Queen Anne Ave

412 Queen Anne Avenue N, Seattle, WA 98109

RECOMMENDATION
APRIL 2020
PROJECT # 3033479-LU

PERSPECTIVE OF CORNER MASSING AND ARTICULATION

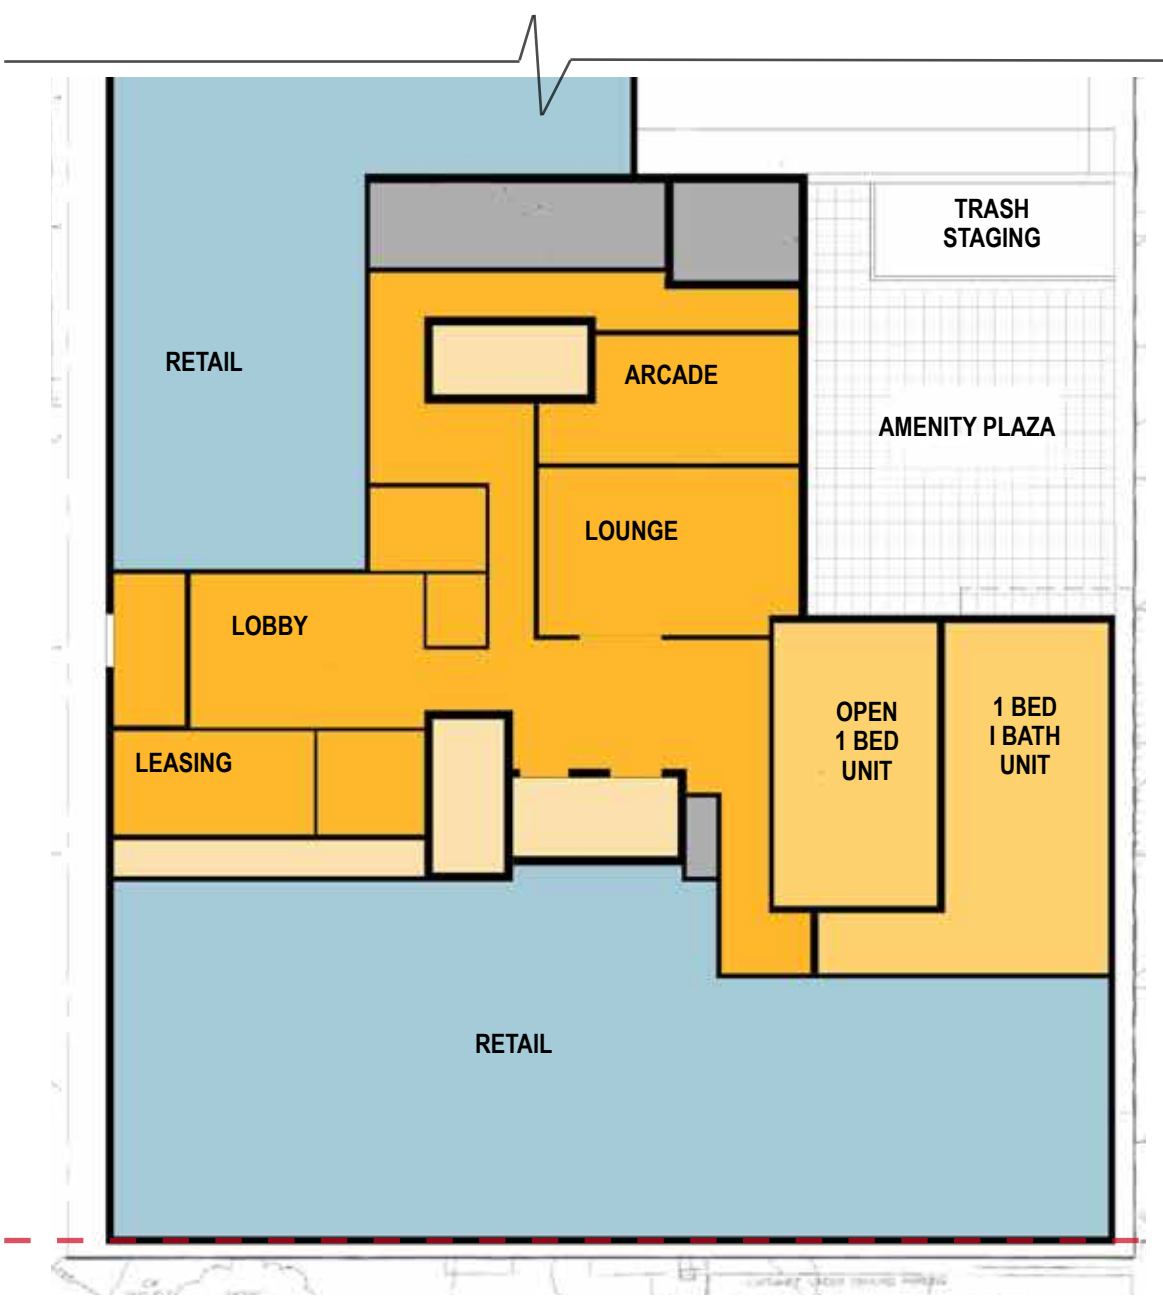
V v. The Board expects to see high quality materials and detailing applied to the entire building, especially at the street-level.
(DC2-D Scale and Texture)

RESPONSE: Brick, architectural grade concrete, aluminum storefront, textured metal panels and Parklex wood paneling are proposed for the exterior finishes along the street-level facades, along with metal canopies with synthetic wood soffits. The upper levels are proposing large glazing areas, painted cement board panels, synthetic wood accent boards, painted metal and glass railings, and large windows. Special attention will be given to panel reveals details and material transitions, especially at the corner massing.

vi RECOMMENDATION MEETING: LEVEL 1 PLAN

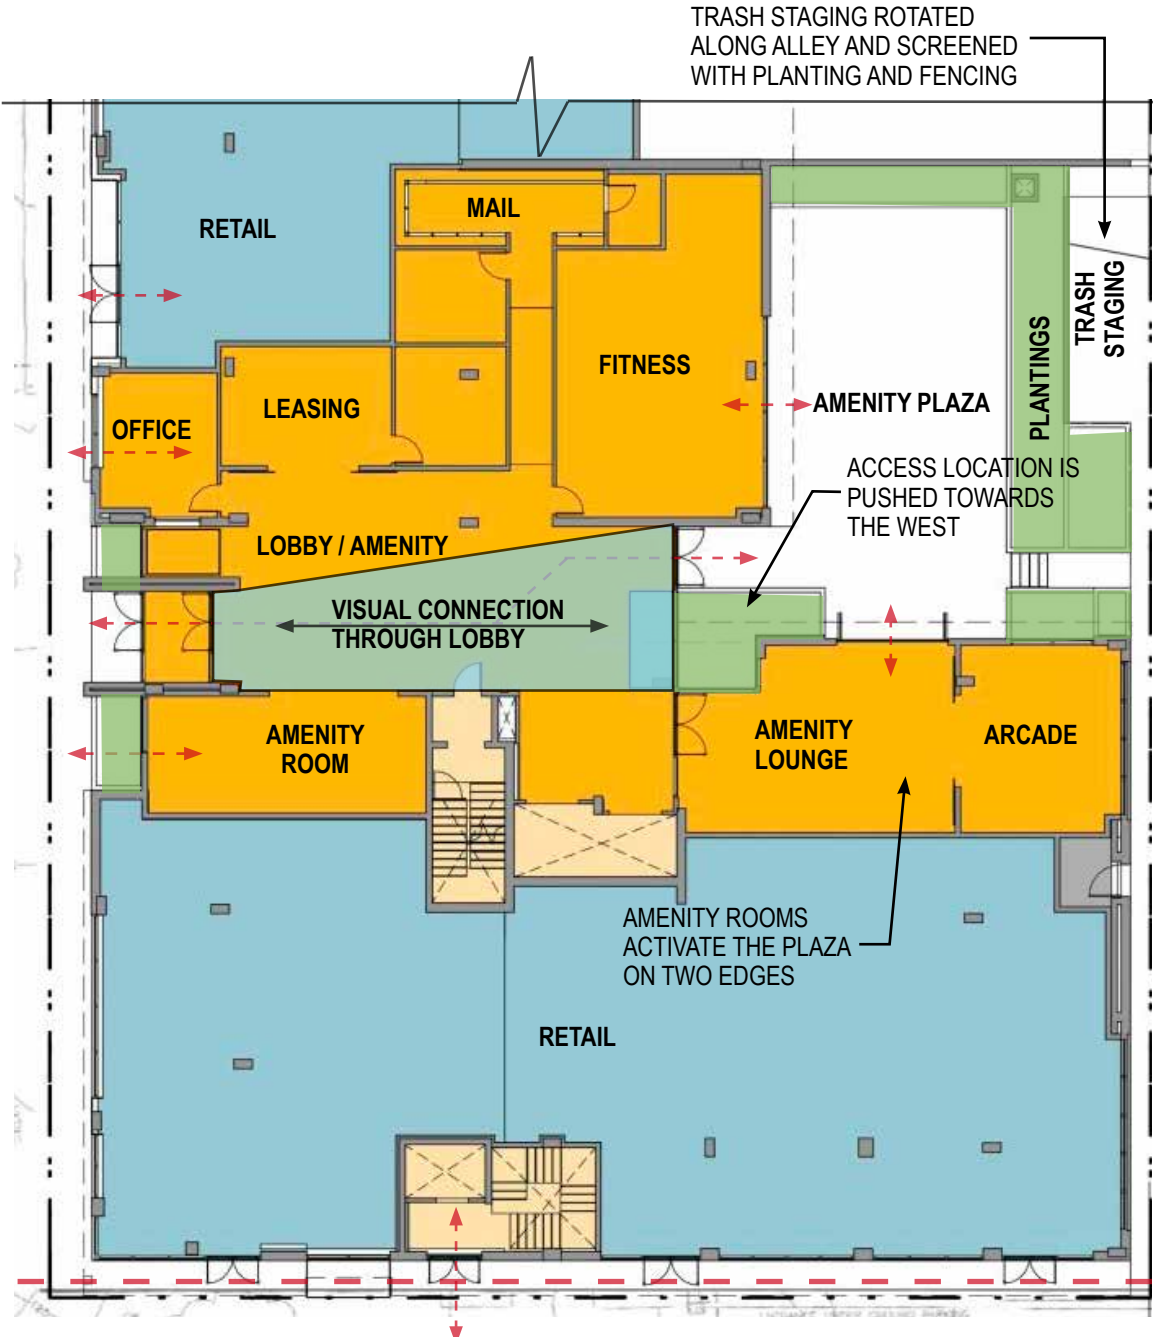
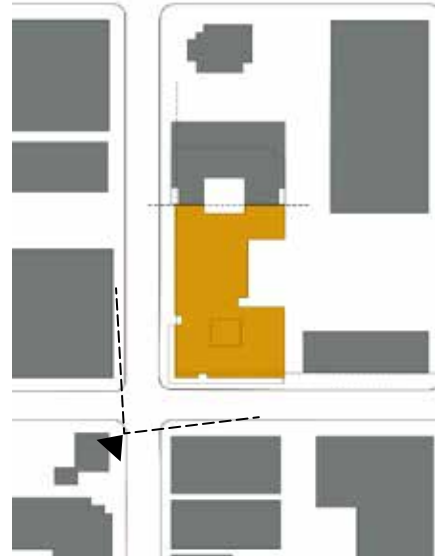
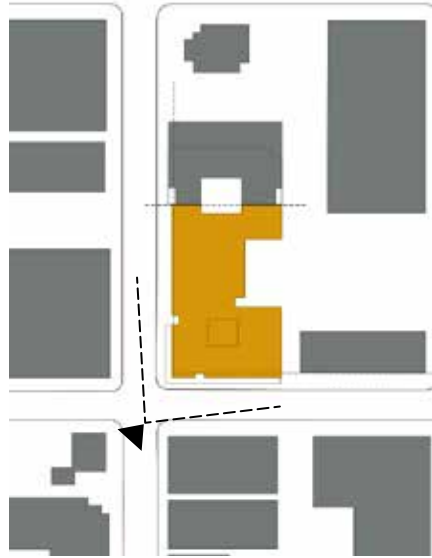
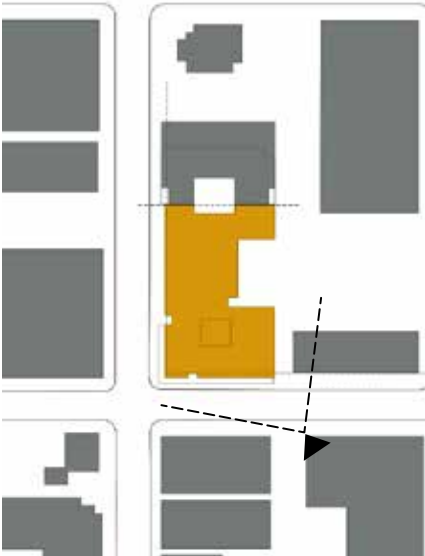
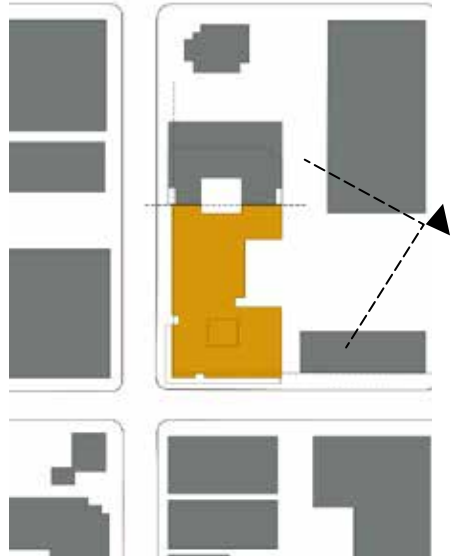
vi. The Board was concerned with the lack of light into the proposed amenity space resulting from the location at ground floor and tucked between tall walls. The Board was also concerned with the proximity of the amenity area to the trash area. At Recommendation stage of review, the Board expects to see a study of other locations (especially if this was a code required amenity meant to be a habitable area for residents); design strategies to create a lively, pleasant space; and consideration of the interior/exterior relationships of the amenity and ground floor uses. The Board suggested a connection from the amenity space to the lobby if feasible. (DC3-A-1. Interior/Exterior Fit, PL1-C-1. Selecting Activity Areas, CS1-B-2. Daylight and Shading)

vii. The Board expects to see further development of the east blank wall condition at the next meeting. The Board commented this wall would be very visible and warranted further study including breaking up the mass and/or integrating glazing where feasible (perhaps down the hallway). (DC2-B-2. Blank Walls)

RESPONSE: Special attention was given to the development of the residential entry, lobby, and amenity spaces. The main entry off Queen Anne Ave N was shifted to the north in order to provide a clear visual connection through the lobby to the exterior plaza on the east side of the building. The residential units that were located at level 1 were removed, and the exterior plaza area is surrounded by the fitness room and lounge. The main lobby and the lounge will have direct access to the plaza area, making it an extension of the interior spaces and activities. The trash staging area was shifted to the north and is buffered from the common area with stepped concrete planters and a metal fence element with textured panel accents.

RESPONSE: The north blank wall has become a zero lot line condition with the addition of the northern lot. Where visible, the north wall is treated with both material variations and changes in the plane to provide some visual interest and continuity in design concept established on the other facades. The blank wall condition is minimized by matching the adjacent building blank wall existing conditions and with upper level setbacks to the massing.

- Changes from EDG:
- Added recessed lobby entry at Queen Anne Ave N to emphasis location
 - Established a direct visual connection between street entry and plaza access through the lobby space
 - Shifted amenity plaza access wall massing West to shorten the distance between street and plaza entry points, pushing residential program uses North and South of the lobby area.
 - Removed ground level residential units which were de-emphasizing the common use of the plaza space
 - Added amenity rooms with direct exterior access, creating engaging active areas on two sides of the plaza.
 - Rotated the trash staging area and provided planter buffers and metal fencing with textured panel accents.
